# Access Compliance Report

## Public Rights-of-Way

| Intersection ID: 27738                  | Main Street: JAMES JACK LN | Cross Street: VILLALONGA LN             | Location: NW           |
| ADA ID: 24C0F00BF670                    | Ramp Type: PerpDiag        | Initial Pass/Fail: Fail                 | Overall Compliance: No |

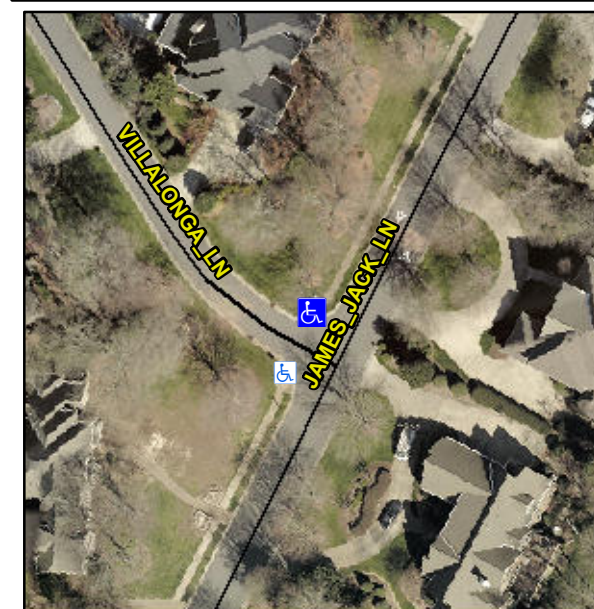
**Not Found, R304.5.1, R304.5.3**

| Compliance | Description           | Data  | Compliance | Description                 | Data  |
|------------|-----------------------|-------|------------|-----------------------------|-------|
| No         | Ramp Width (in)       | 36.0  | No         | Ramp XSlope (%)             | 4.2   |

**Remove & Replace Curb Ramp With Two New Directional Ramps or Equivalent.**
